United States Patent and Trademark Office

APPLICATION NO.	FILING DATE	FIRST NAMED INVENTOR	ATTORNEY DOCKET NO.	CONFIRMATION NO
09/475,452	12/30/1999	ANAND MURTHY	042390.P7794	6341
7:	590 12/14/2006		EXAM	INER
MICHAEL A BERNADICOU			LEE, EUGENE	
BLAKELY SOKOLOFF TAYLOR & ZAFMAN LLP 12400 WILSHIRE BOULEVARD			ART UNIT	PAPER NUMBER
7TH FLOOR			2815	
LOS ANGELE	S CA 90025

Application No.	Applicant(s)				
Office Action Summary	09/475,452	MURTHY ET AL.				
Office Action Summary	Examiner	Art Unit				
7. 20.00 0.00 0.00	Eugene Lee	2815				
The MAILING DATE of this communication appears on the cover sheet with the correspondence address Period for Reply						
A SHORTENED STATUTORY PERIOD FOR REPLY WHICHEVER IS LONGER, FROM THE MAILING DA Extensions of time may be available under the provisions of 37 CFR 1.1 after SIX (6) MONTHS from the mailing date of this communication. If NO period for reply is specified above, the maximum statutory period of Failure to reply within the set or extended period for reply will, by statute Any reply received by the Office later than three months after the mailing earned patent term adjustment. See 37 CFR 1.704(b).	ATE OF THIS COMMUNICATION 36(a). In no eve

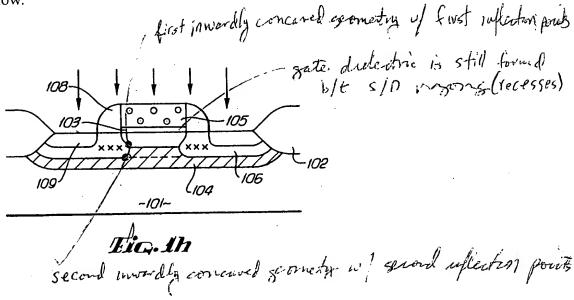
4. In view of the 112 rejection, claims 1, 8, 9, and 11 are rejected under 35 U.S.C. 103(a) as being unpatentable over Takeuchi 5,060,033. Takeuchi discloses (see, for example, Fig. 1h) a MOS transistor (device) comprising an insulating film (gate dielectric) 103, substrate (substrate that has a first conductivity region) 101, gate electrode 105, side wall insulating film (pair of sidewall spacers) 108, and source and drain regions (a pair of silicon or silicon alloy inwardly concaved source/drain region of a second conductivity type formed in said substrate) 106. The source and drain regions are inwardly concaved and bend (inflection points) directly underneath the gate electrode. The channel region (first channel region) directly beneath the gate electrode is larger that the channel region (second channel region) between the inflection points.

Regarding the limitation "recesses, wherein the recesses have an inwardly concaved geometry with inflection points; ... a silicon or silicon alloy layer deposited into the recesses", this is a product-by-process limitation of forming the source/drain regions, and since the claims are directed towards structure, and Takeuchi structurally discloses source/drain regions, the claims are not structurally distinct from that what is shown in Takeuchi.

The new limitations are still disclosed in Takeuchi 5,060,033. See FIG. 1h from Takeuchi 5,060,033 below.
